THE CONTROL OF HEAVY LOADS AT
NINE MILE POINT UNIT 2

DOCKET NO. 50-410

Nine Mile Point Unit 2

FIGURE 1.2-17

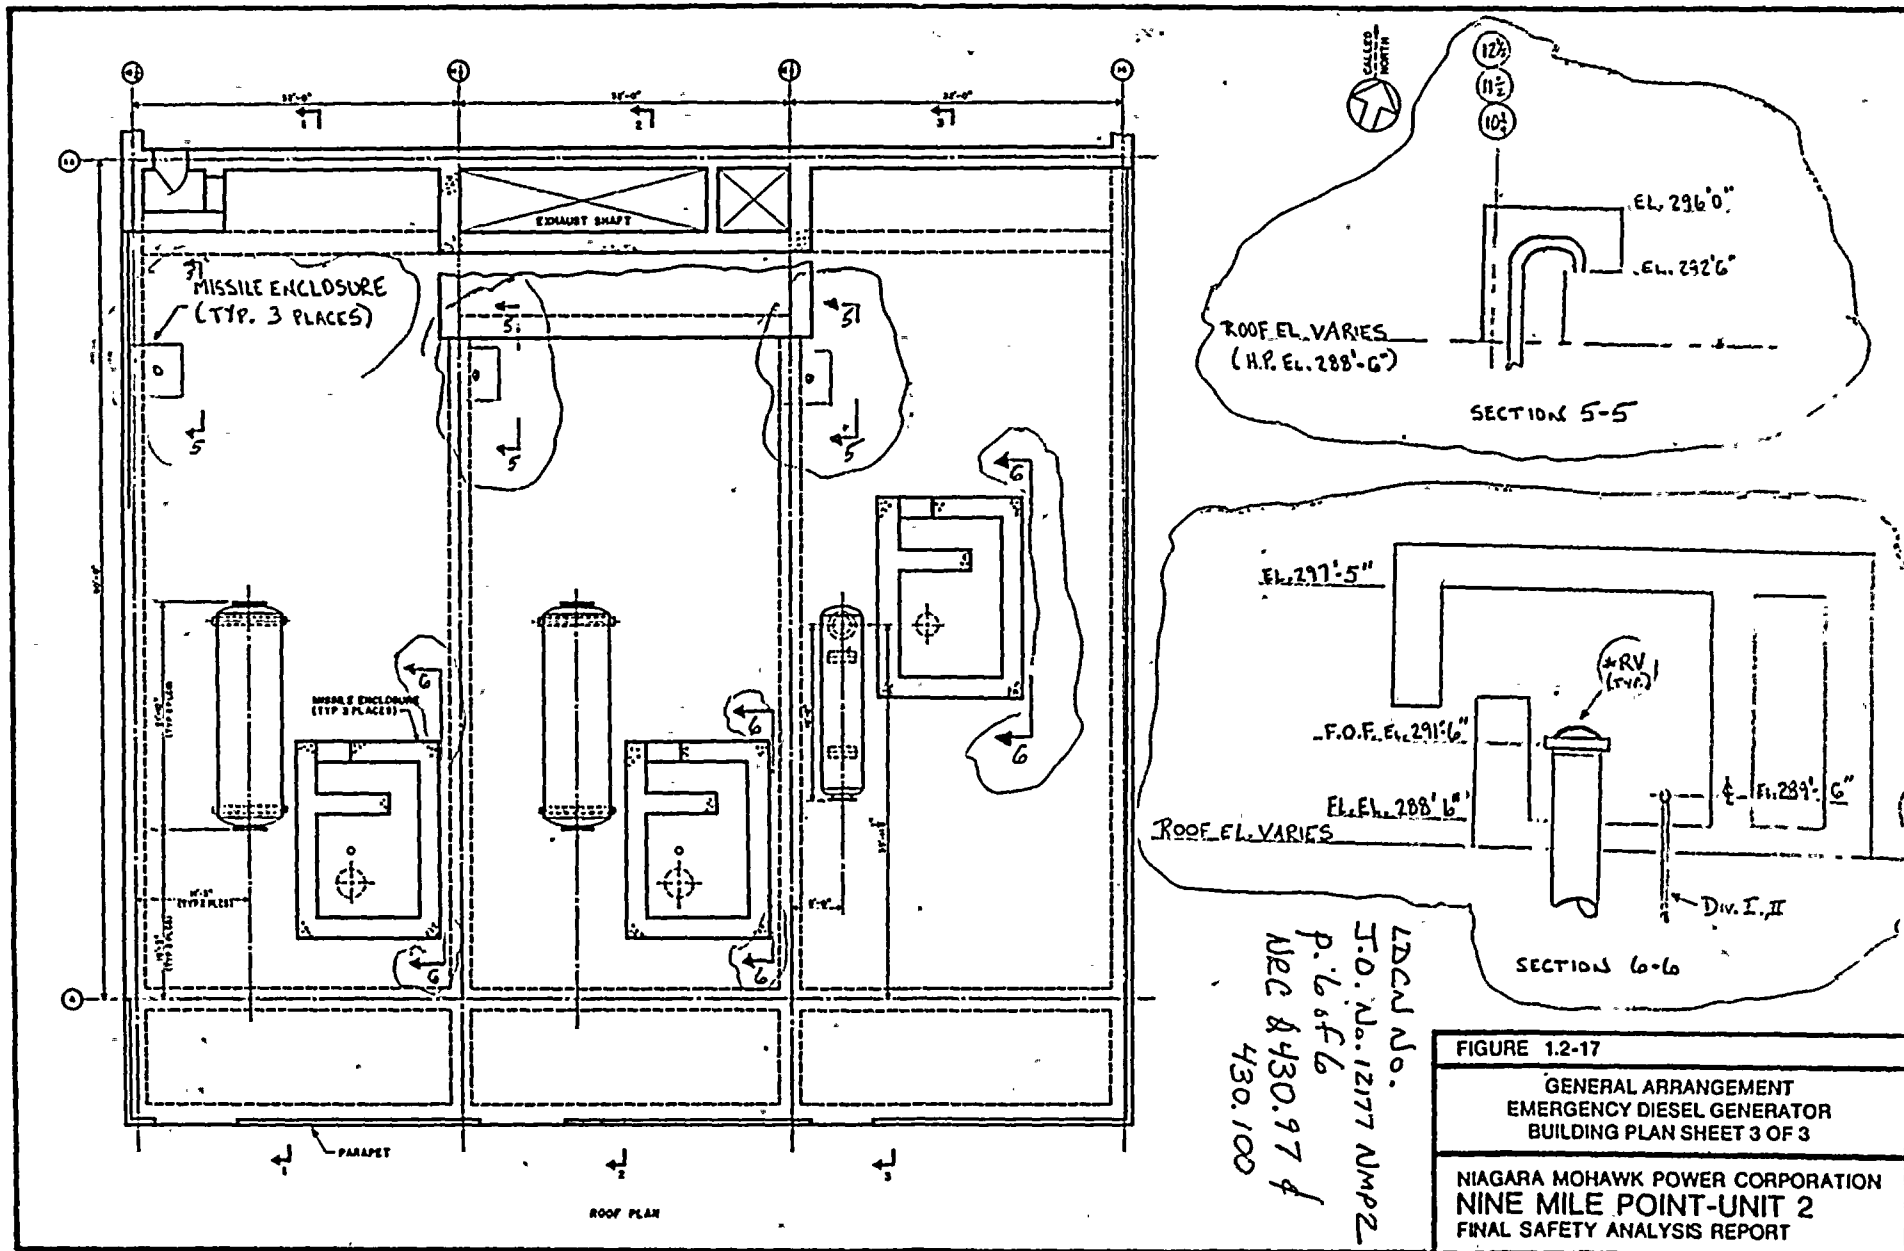
FSAR Figures 9.5-49 through 9.5-51, and 1.2-17 through 1.2-19, do not provide adequate details of the missile protection provided for the diesel generator combustion air intake and exhaust systems. Provide additional plan elevation, and section views, as required, which clearly show what the missile protection consists of, where it is located relative to the intakes and exhaust, and the relationship of the protective devices with the diesel generator building and other buildings, as appropriate. (SRP 9.5.8, Part I)

10. The missile enclosures appear in Figure 1.2-17 for diesel generator divisions I, II, and III. Section 6-6 on this figure illustrates the diesel exhaust relief valve missile protection.
